E E UE A A EEME E A E
E E ME A A
AM A E E A U

The purpose of this correspondence is to inform DTMR of some proposed changes to access arrangements for the development, and to seek in principal agreement to the changes. This agreement will subsequently support an application for a permissible change in accordance with Sections 369 and 370 of the Sustainable Planning Act 2009, which will be lodged with the State Assessment and Referral Agency. The reason for this initial correspondence with your Department is to reach agreement on the particulars of the changes, in advance of the time when the permissible change request can be lodged, being when the approval takes effect after the end of the submitter appeal period.

□r□□□ed □□an□e□

Overall Site Plan

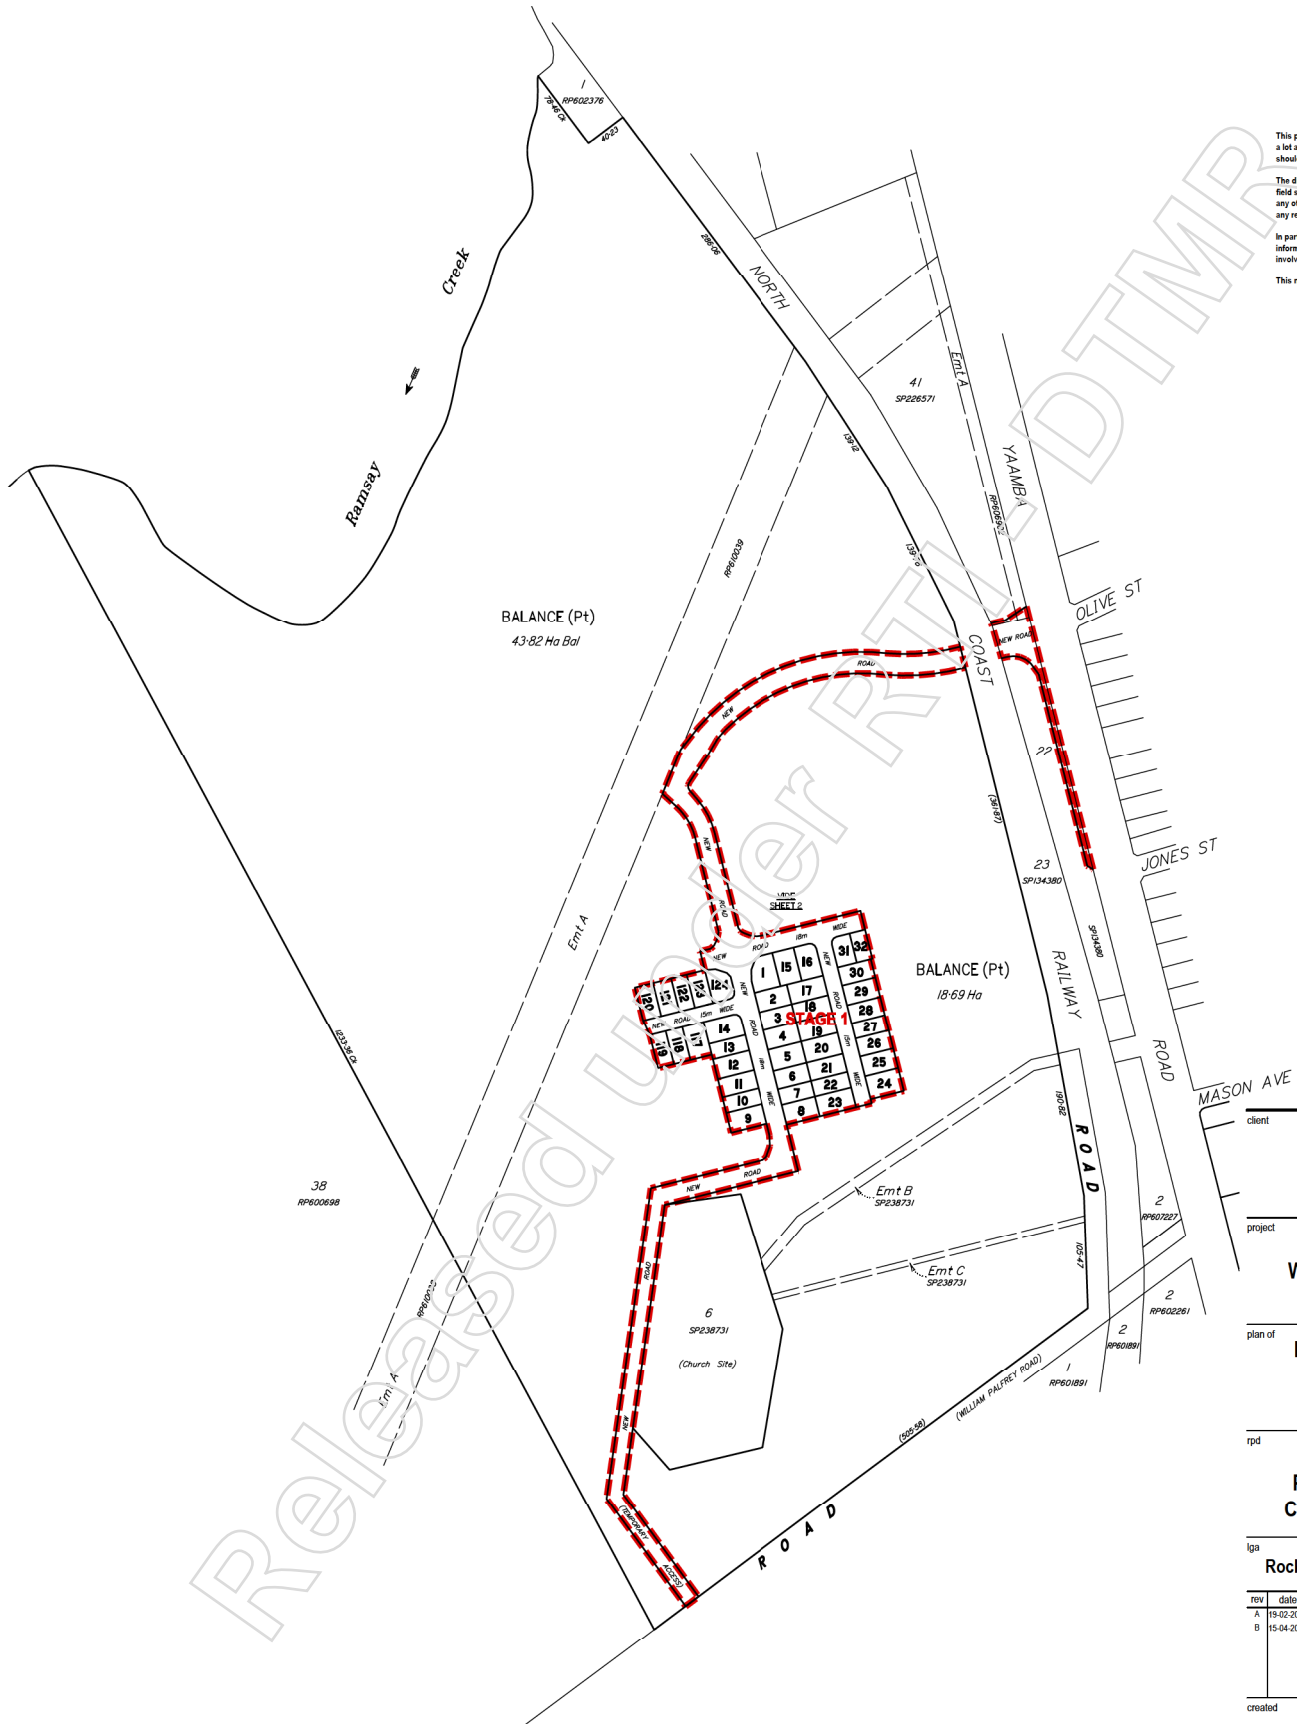
Attachment A includes a copy of the proposed lot reconfiguration plan.

Stage 2 Interim Geometry (501 – 1,275 dwellings)

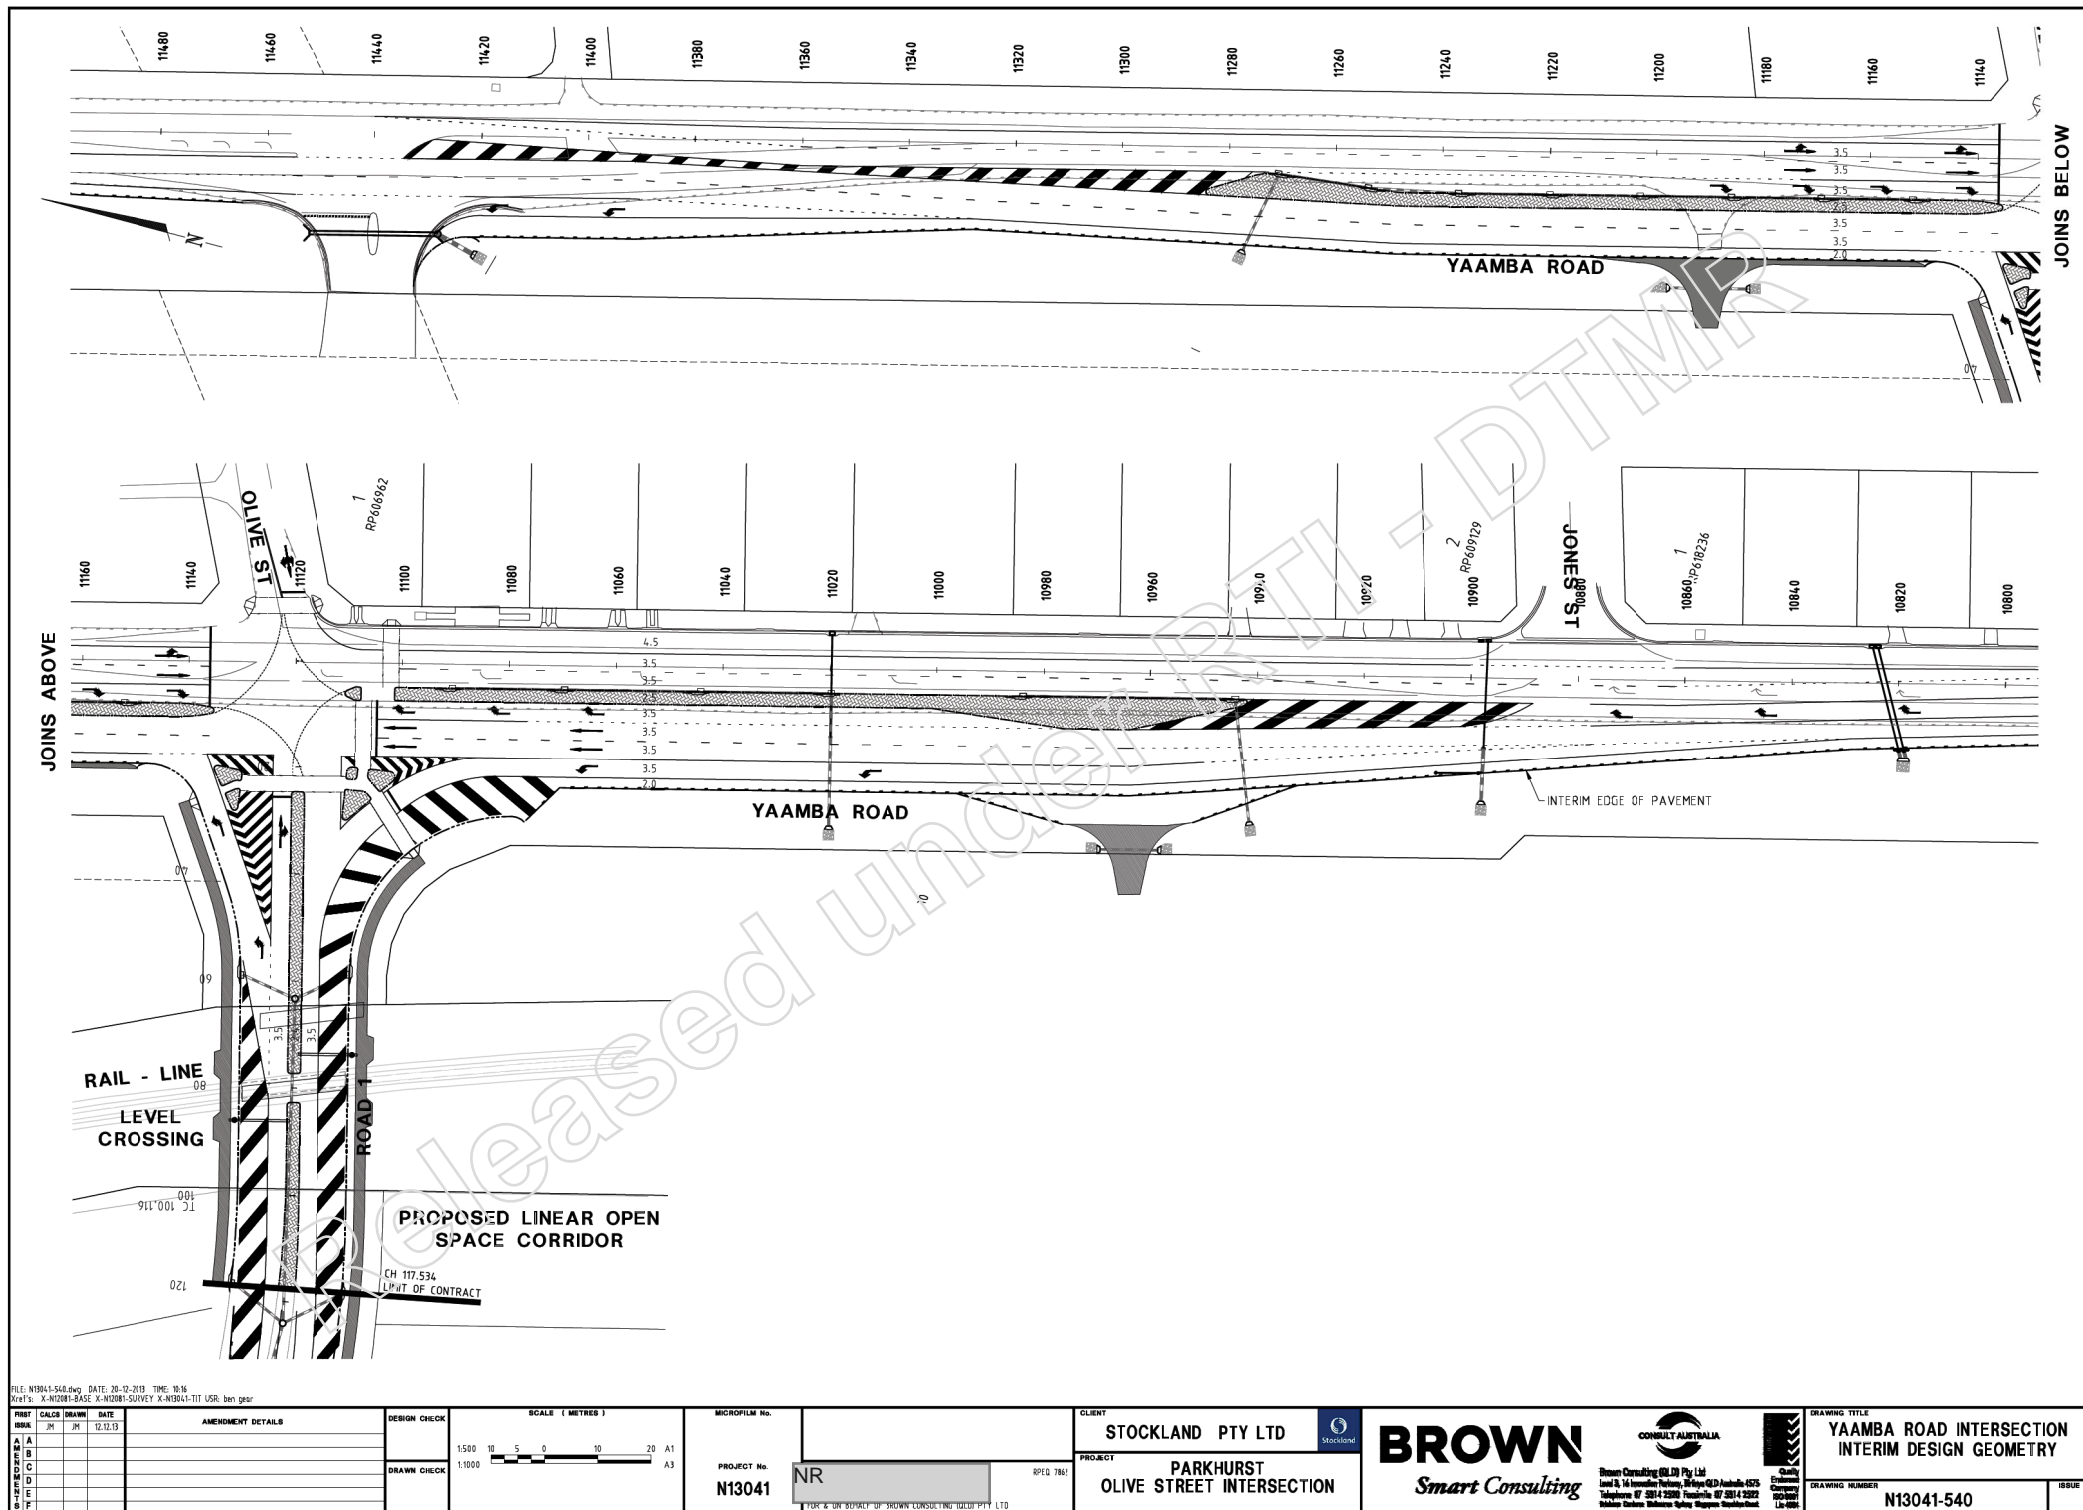
Our report detailed the proposed staging of this intersection which included an interim proposal (**Attachment B**) which showed the same detail with respect to the local duplication of the Bruce Highway and signalisation of the intersection. The geometry differed with respect to the left turn lane from the Bruce Highway into the subject site whereby only 1 of the 2 left turn lanes was to be constructed. *"This geometry is expected to operate within the acceptable limit of operation until such time as site generated traffic exceeds 11,475 vehicles per day."*¹ The trigger for the ultimate geometry is 1,275 detached dwellings.

Stage 1 Interim Geometry (up to 500 dwellings)

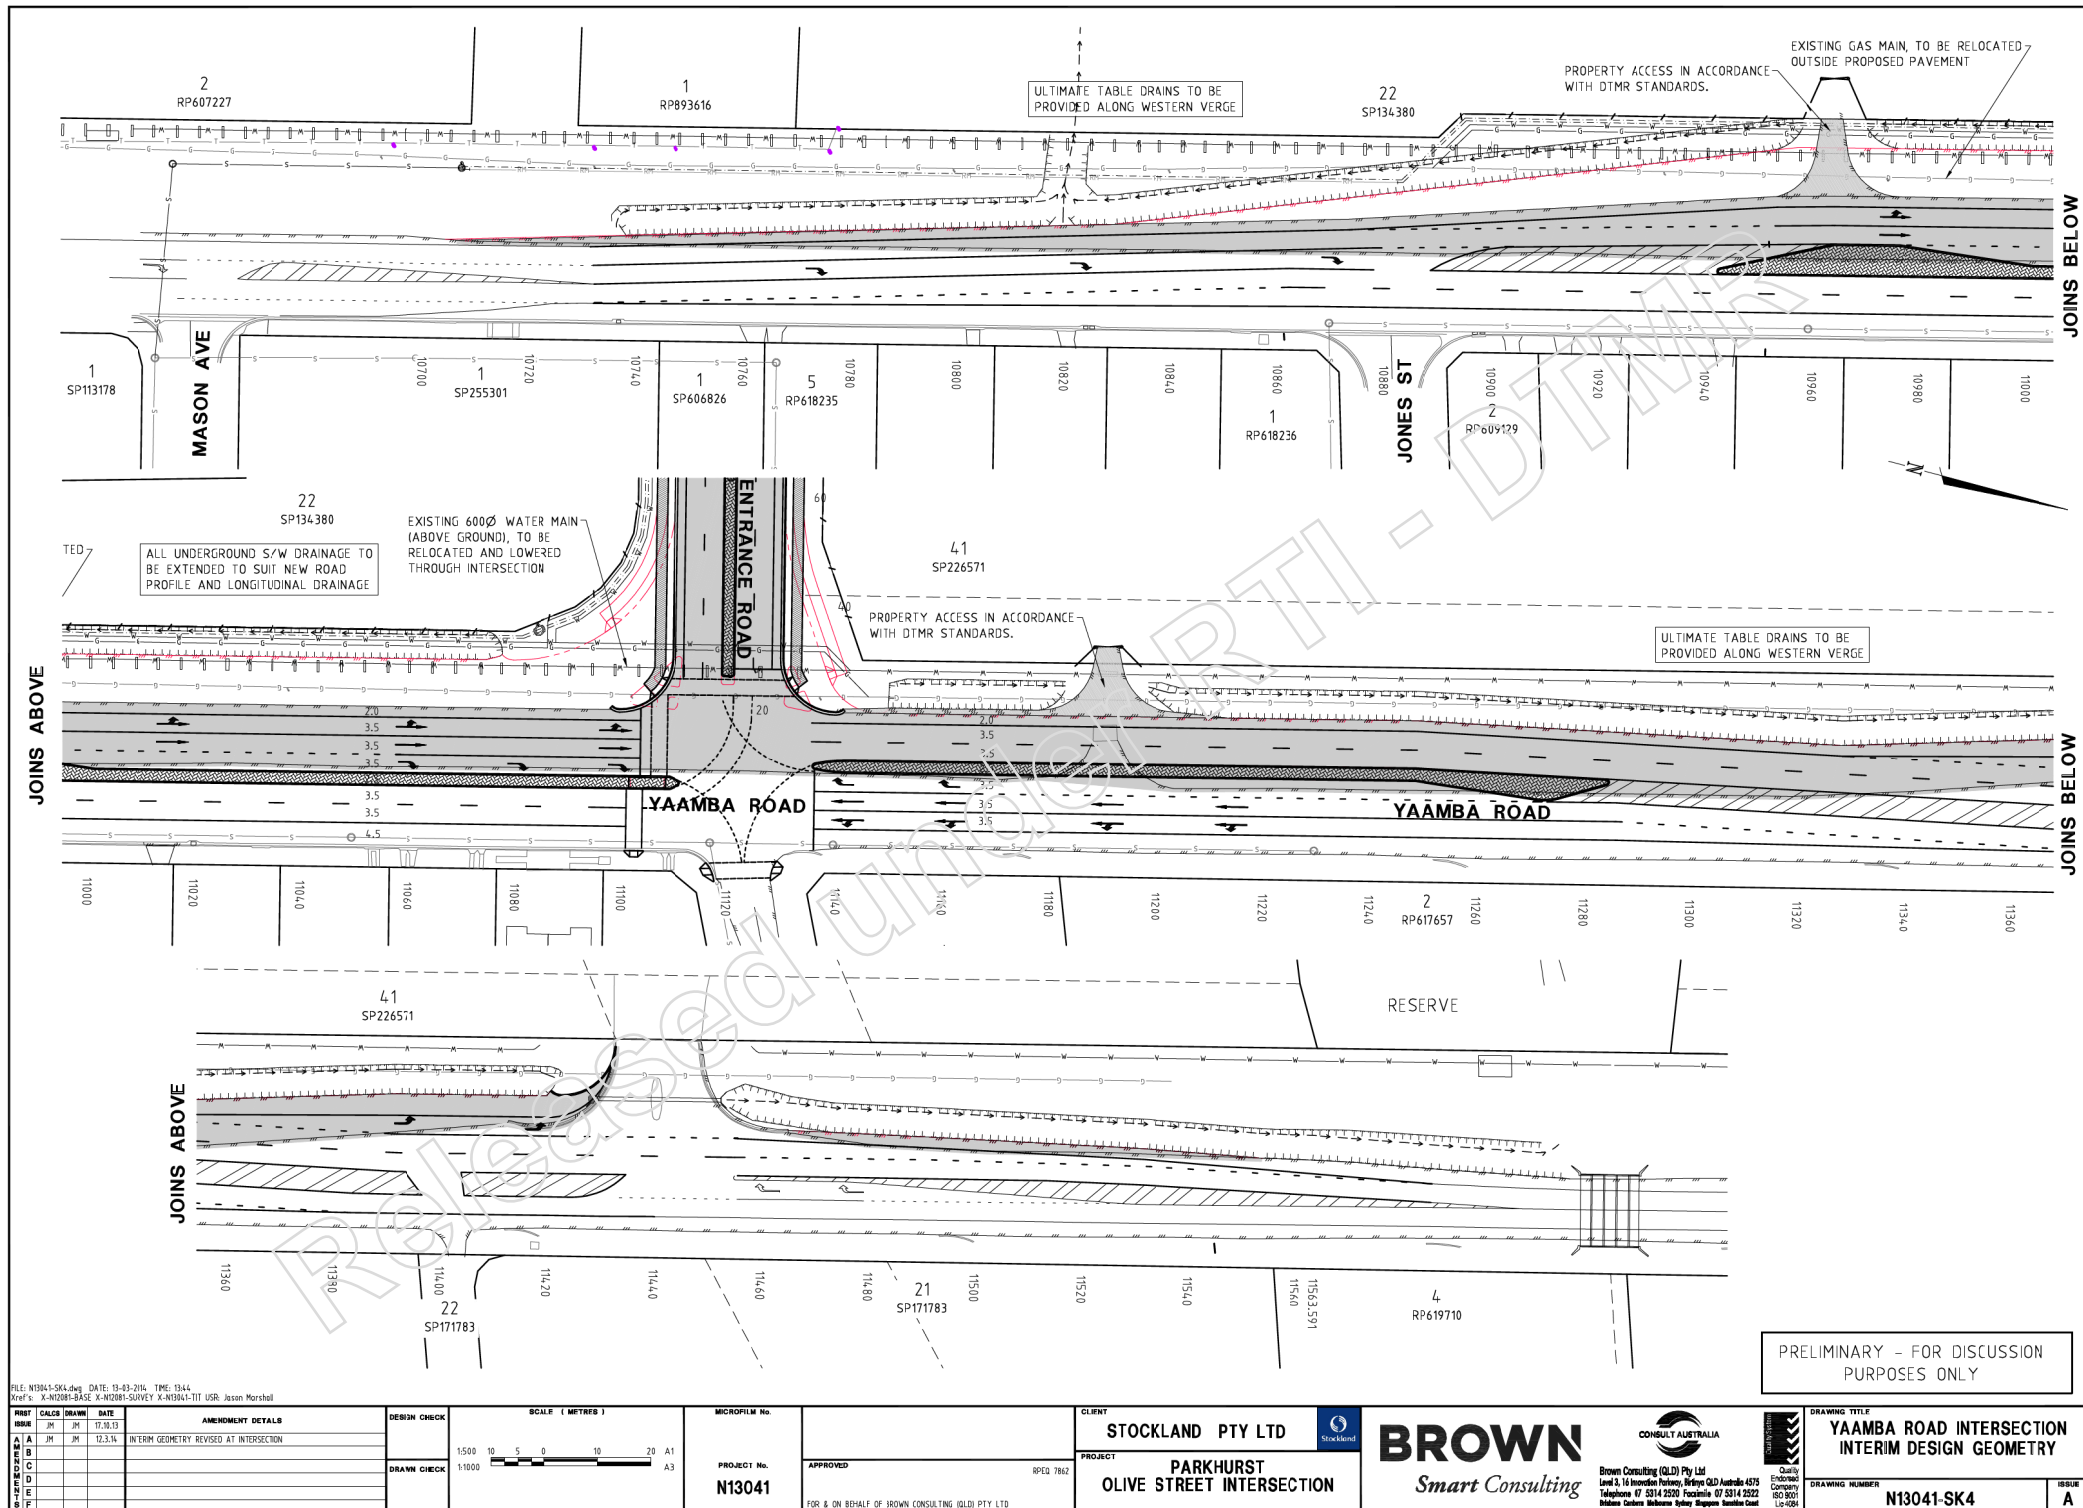
The geometry depicted in **Attachment C** shows the new geometry proposed at the year of opening. This shows same detail with respect to the local duplication of the Bruce Highway and signalisation of the intersection (i.e. two through lanes in each direction). The only change being that left turn vehicles will use the kerbside lane in lieu of an auxiliary turn lane.

The results show that the new interim geometry (**Attachment C**) is expected to operate below 65% degree of saturation with full occupancy of 500 dwellings in 2025. TMR's acceptable limit of operation for traffic signals is 90%.
